**Montrose Crossing, Project and Site Plan Amendments, 91994003B and 81995036E**

**date of staff report:** October 21, 2011

**description**

- Addition of free-standing bank and restaurant on existing parking lot; minor changes to parking, site, utilities, and landscaping associated with new buildings and existing retail store;
- A subsequent minor resubdivision will reincorporate land conveyed to SHA;
- Located in the northeast quadrant of the intersection of Rockville Pike and Randolph Road; and
- On 33.38 gross acres of RMX-3C-zoned land within in the North Bethesda/Garrett Park Master Plan area.
- Applicant: BVS Montrose, LLC; filed on 6/20/11.

Landscape Plan for Proposed Bank and Restaurant

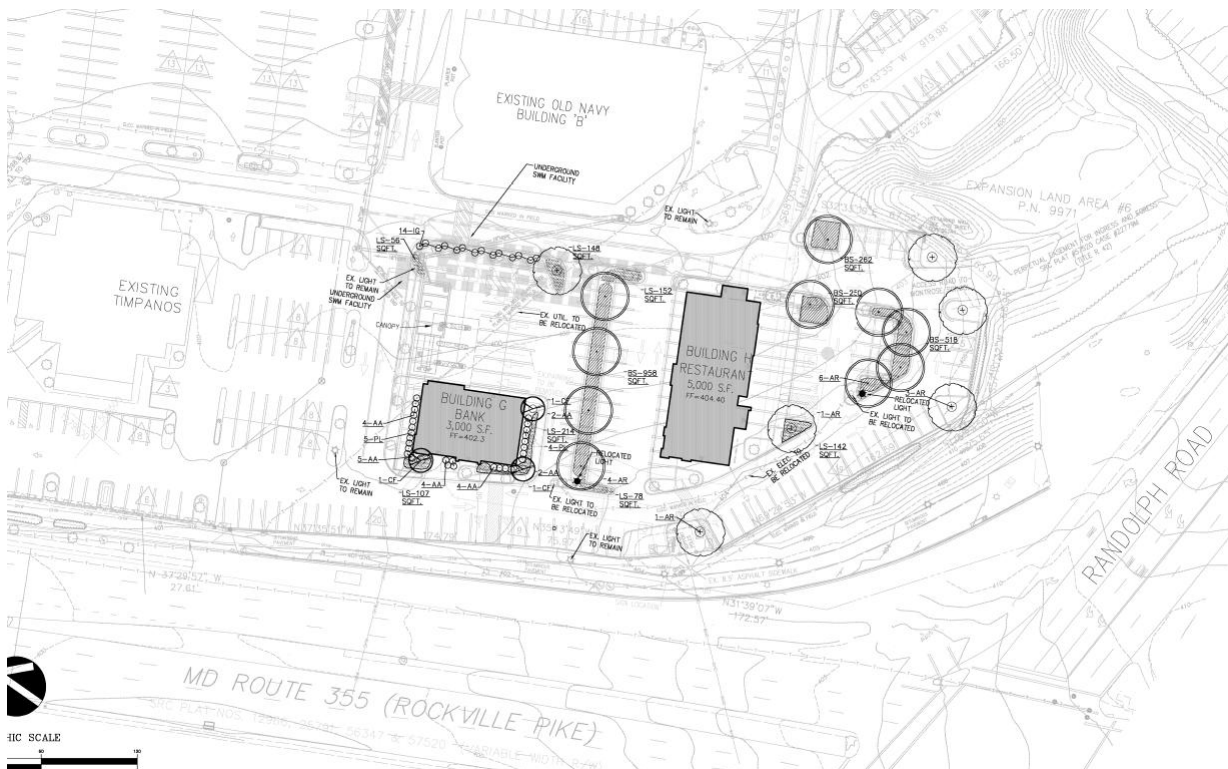
The proposed development will use approved density that was removed for the construction of Nebel Street to build a free-standing bank and restaurant. Additional changes are requested to accommodate utilities and permanently remove the “festive place maker” originally required at the corner of Rockville Pike and Randolph Road. A minor subdivision application has been filed to add 1.709 acres of land previously conveyed to the State Road Commission for construction of the Montrose Parkway interchange. Finally, numerous minor site, landscape, parking, and lighting changes will be made to accommodate the new buildings and utilities.
